City of Santa Fe, New Mexico

memo

2026-012490-HDRB. 507 Paseo de Peralta. Downtown & Eastside Historic District. Marisol Ortiz, agent for Peralta's Walk LLC, owner, proposes to construct a 4,235 sq. ft. multi-family residence to a height of 25'-0" where the maximum allowable height is 22'-2" on a vacant lot. An exception is requested to Section 14-4.6(F)(2) for exceeding the maximum allowable height.

Figure 3: Proposed Site Plan

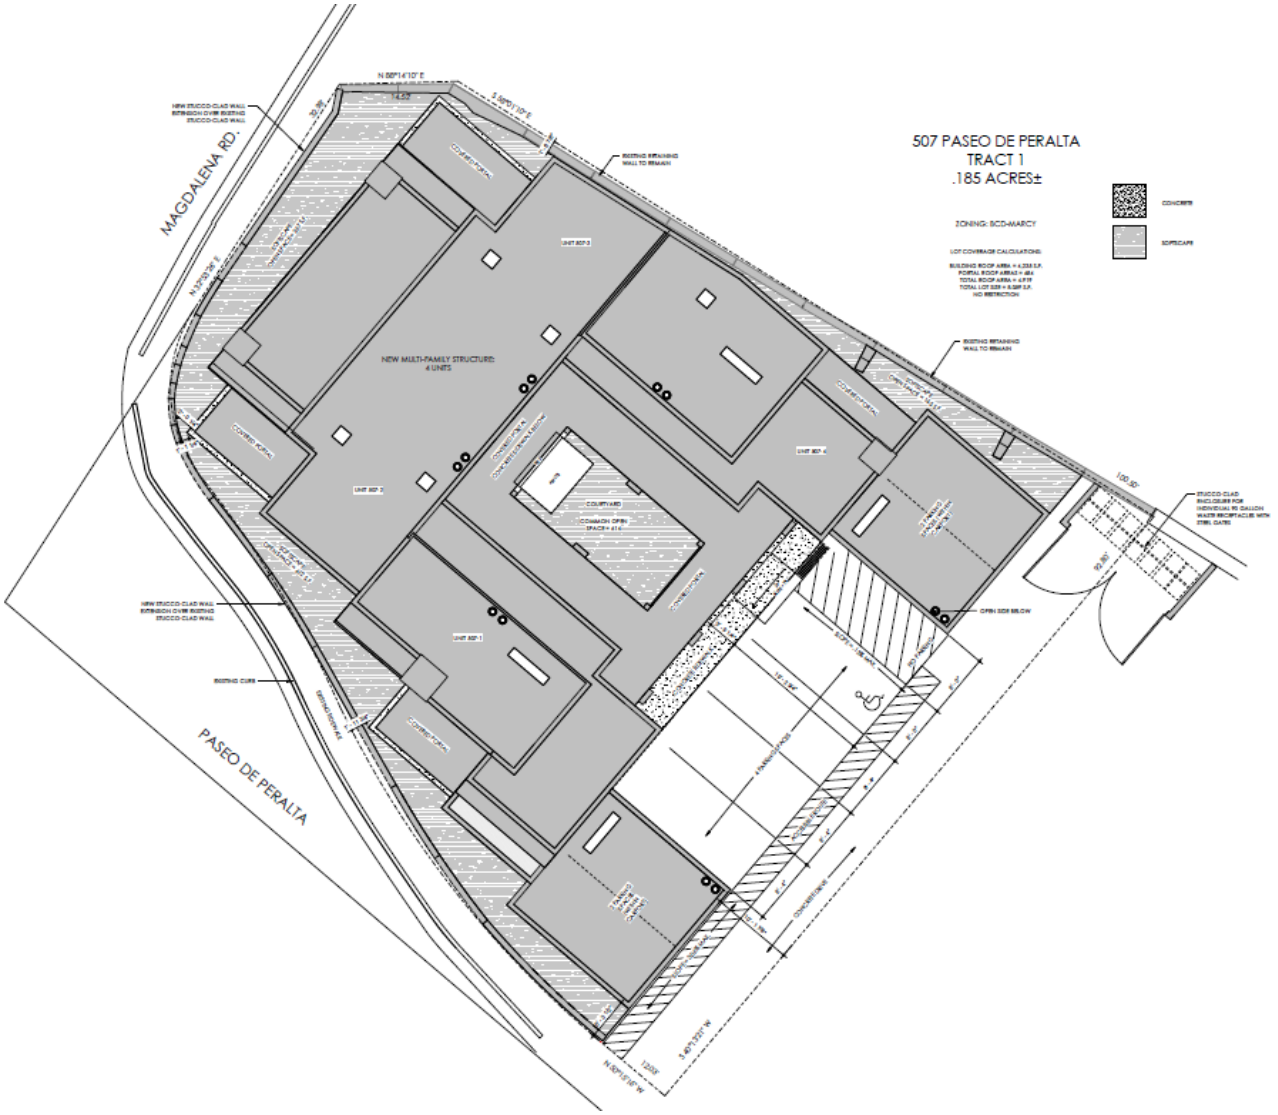
The case was postponed for a redesign taking into consideration the comments from the Board and the public. The applicant has addressed the cantilevered roofs by changing to parapets, eliminated the metal elements by using wood, in setting the windows 3", and bull-nosed the corners with 3" radii. The drawings were corrected to show the windows at a more accurate distance from the roofline. While the overall lot coverage is not altered, the applicant confirmed that the corner at Magdalena will have site visibility due to the setbacks and the careful location of an open portal in that area.

Figure 6: Proposed South Elevation (Paseo de Peralta Facade)

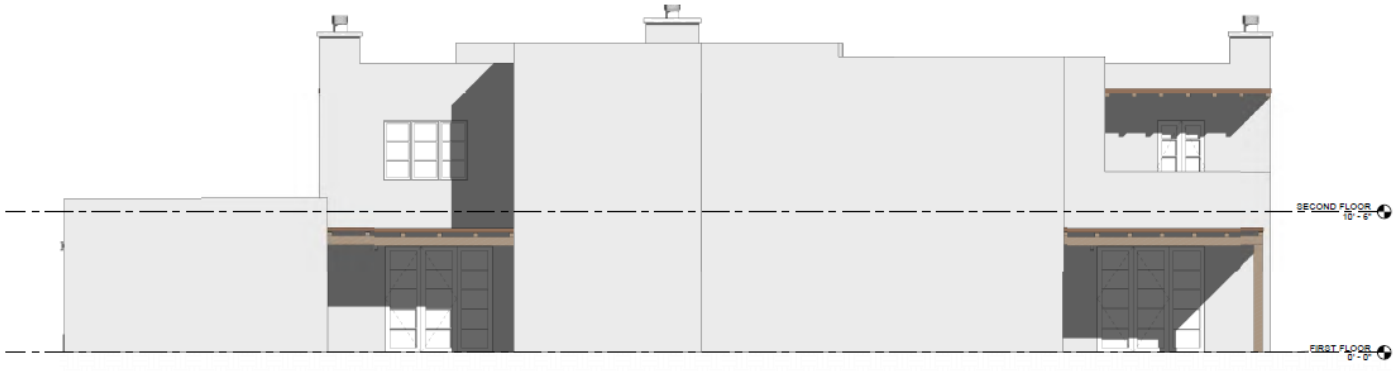
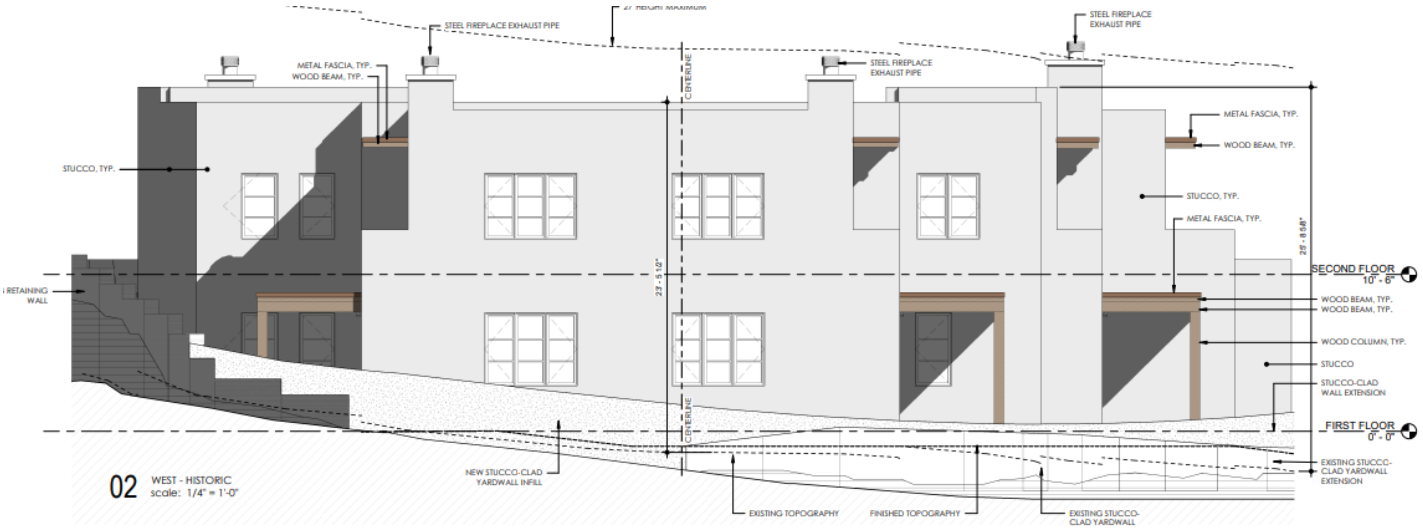
The applicant has provided updated elevation drawings specifying the maximum heights at the midpoint of the street facing facades along Paseo de Peralta (24'-11 ½") and Magdalena (23'-5 ½"). Per Section 14-4.6.F.2.III.a, in historic districts, height shall be measured as, "*the vertical distance measured between the highest part of a structure and the existing grade or finished grade, whichever is more restrictive, at the midpoint of the street-facing facade...excluding rooftop appurtenances.*" The applicant is requesting a height of 25'-0" where staff's calculation provides for a maximum allowable height of 22'2".

Applicant Response: Currently, the proposed site is an abandoned parking lot with a large, stucco-clad retaining wall bordering the rear side. Past the wall are two residences that are elevated above the property. Allowing a taller building in this location still allows the building to fit within the character of the streetscape and helps to soften the current abrupt juxtaposition of the Paseo de Peralta streetscape to the houses elevated above.

Applicant Response: The new building is proposed as a two-story structure to permit four (4) units on a compact site. The building height has been kept to 25'-0" toallow higher ceiling heights and the required amount of structure between floors and in the roof.

Staff Response: Staff finds that this criterion is met. The character of the Downtown and Eastside District is one of dense residential development with a mix of commercial and institutional uses. Nearby the proposed development you find several tall historic structures including the Scottish Rite Temple, City Hall and the Federal Courthouse, in addition there are modern buildings like Wells Fargo and several two-story residences along the north stretch of Paseo de Peralta and tucked in along the neighborhood above the site. While many of these structures (institutional and multifamily) are excluded from the historic height calculations, their presence on the streetscape is notable to the district character. The proposed design meets the standards of the recent Santa Fe Style, which allows for more than two stories if the facades include projecting or recessed portals setback per section 14-4.6(G)(2)(II)(a) "*No building shall be over two stories in height in any facade unless the facade shall include projecting or recessed portales, setbacks or other design elements;"* The proposed design includes these design elements and will not damage the character of the streetscape or the Downtown and Eastside historic district as there are existing structures at a similar height and design. Adding an additional two-story structure at this site will not damage the character of the district.

Staff Response: Staff finds that this criterion is met. It is in the general public's welfare that this vacant infill lot be developed for additional housing downtown in a very walkable and centralized location. The lot is smaller than most on the streetscape. It would be out of character to place multi-family homes with a single-story on this lot.

Staff Response: Staff finds that this criterion is met. The Business Capital District Marcy Street Subdistrict (BCDMAR) allows for structures up to 27'-0". The Historic District limit is 22'-2". The proposed height sits between the two heights at 25'-0" so that it creates a transition from the neighboring residential district to the BCD district.
